XC2700 Derivatives

16/32-Bit Single-Chip Microcontroller with
32-Bit Performance

Edition 22.08.2008

1 History List / Change Summary

Figure 1 Example for Case 2: Interrupt Service for Task C delayed

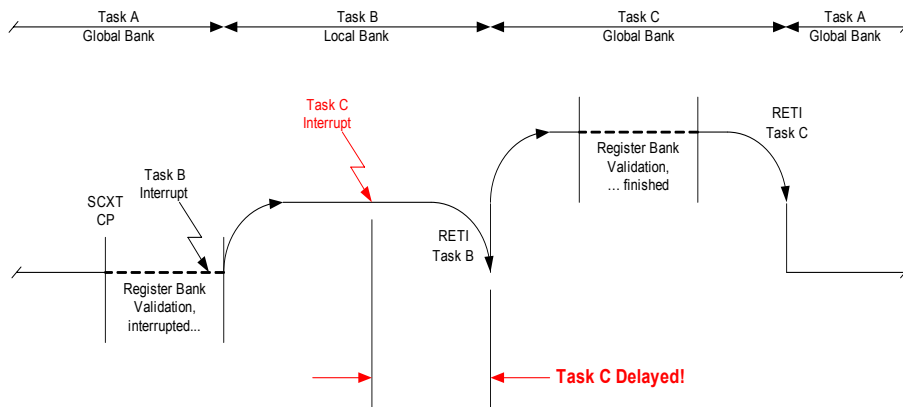
Case 2 (see also Figure 1):

- The Context Pointer CP is written to (e.g. by POP, MOV, SCXT ... instructions) within a routine (Task A) that uses a **global** register bank (bit field PSW.BANK = 00_B), i.e. the context for this routine will be modified,
- This context switch procedure (19 cycles) is interrupted by an interrupt request (Task B) which is programmed (with GPRSELx = 1X_B) to automatically use one of the **local** banks via the bank selection registers BNKSEL0...3 (i.e. the interrupting routine has a priority level ≥12),
- Before the corresponding interrupt service routine is finished, another interrupt request (Task C) occurs which is programmed (with GPRSELx =

00_B) to automatically use the **global** bank via the bank selection registers BNKSEL0...3 (i.e. the interrupting routine has a priority level ≥ 13)

In this case service of this interrupt request (for Task C) is delayed until bit field PSW.BANK becomes 00_B after executing the RETI instruction at the end of the routine (Task B) using the local bank.

Workaround for Case 2

When using both local and global register banks via the bank selection registers BNKSEL0...3 for interrupts on levels ≥ 12 , ensure that there is no interrupt using a global register bank that has a higher priority than an interrupt using a local register bank.

Figure 2 **FIFO structure**

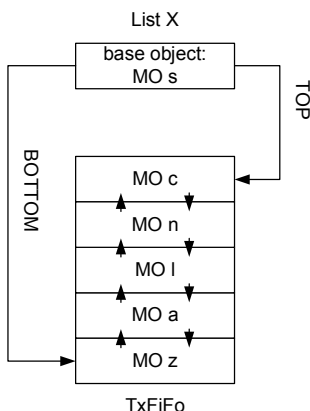
MultiCAN_TC.029 Tx FIFO overflow interrupt not generated

- Bit `MOFCR.OVIE=1`, AND
- `MOFGPR.CUR` becomes equal to `MOFGPR.SEL`

Workaround

If Tx FIFO overflow interrupt needed, take the FIFO base object out of the circular list of the Tx message objects. That is to say, just use the FIFO base object for FIFO control, but not to store a Tx message.

Figure 4 Loss of Arbitration

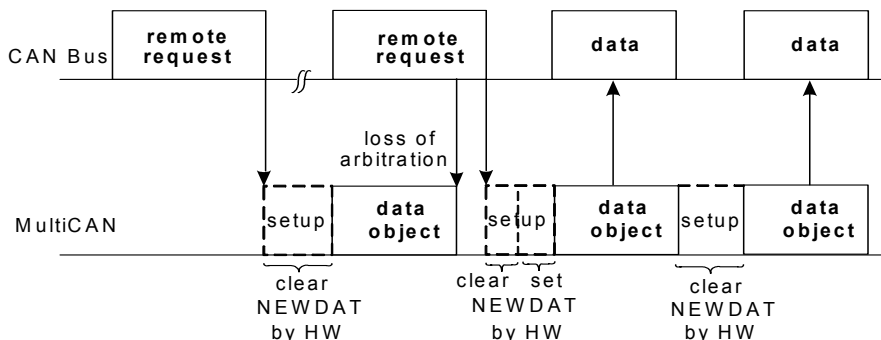
When the appropriate message object (data frame) triggered by the first remote frame wins the arbitration, it will be sent out and `NEWDAT` is not reset. This leads to an additional data frame, that will be sent by this message object (clearing `NEWDAT`).

There will, however, not be more data frames than there are corresponding remote requests.
